On 12-10-21 this section on Doors was sent to PBC, project professionals, and others, in our letter covering multiple topics expressing our positions on the Fairbank Community Center Project. It is the section in **purple** below that we are considering in greater detail now.

Current Information

Option 3: Bathroom Kit

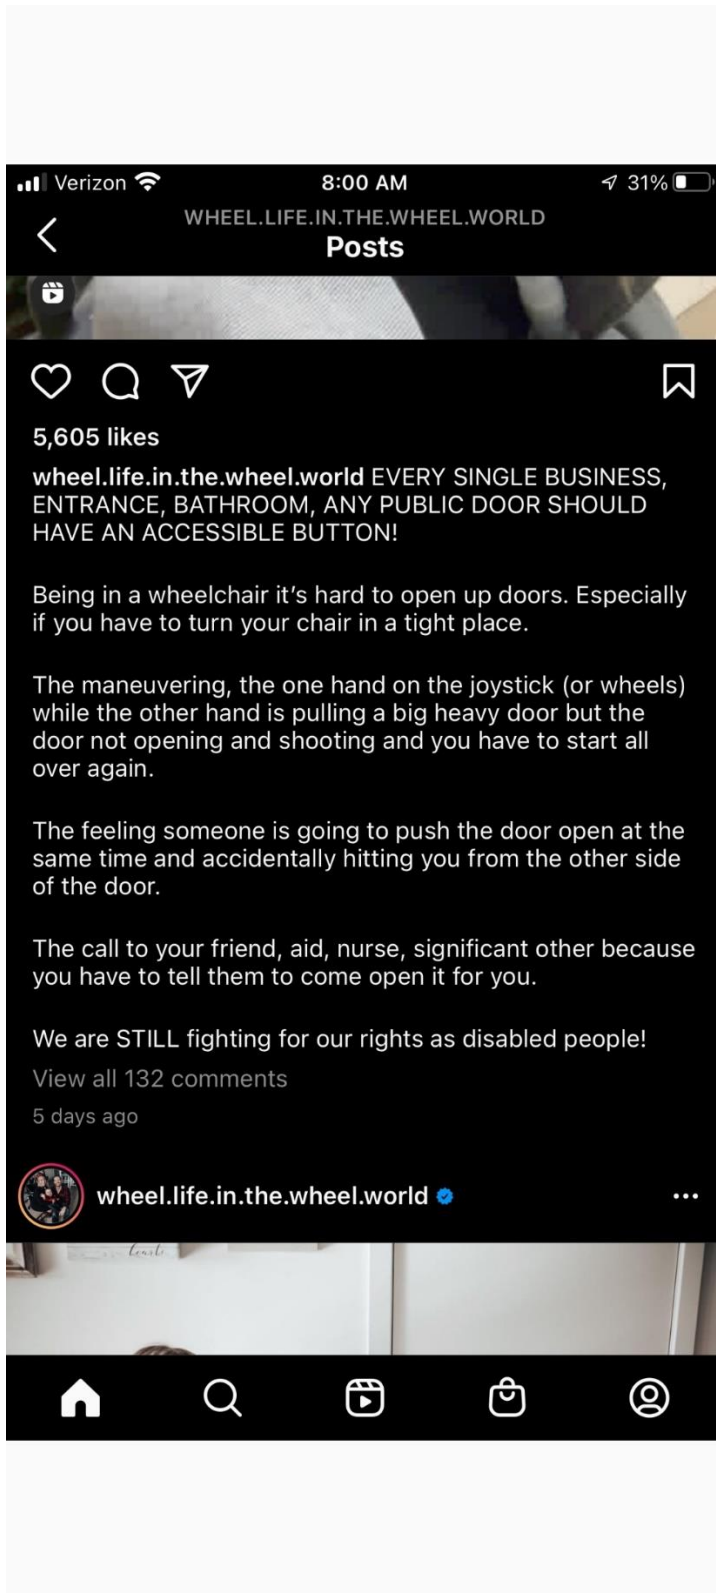
Cons: This option is the most expensive, and is estimated to cost \$5,500 more than the first option. This includes all hardware costs in addition to the cost of the controls.

Pros: With this option, the power assist is integrated into the locking mechanism because all the hardware comes together as a packaged kit. The user locks the door by pushing a button. There is an option to have touchless controls as well, similar to the CX-WC16.
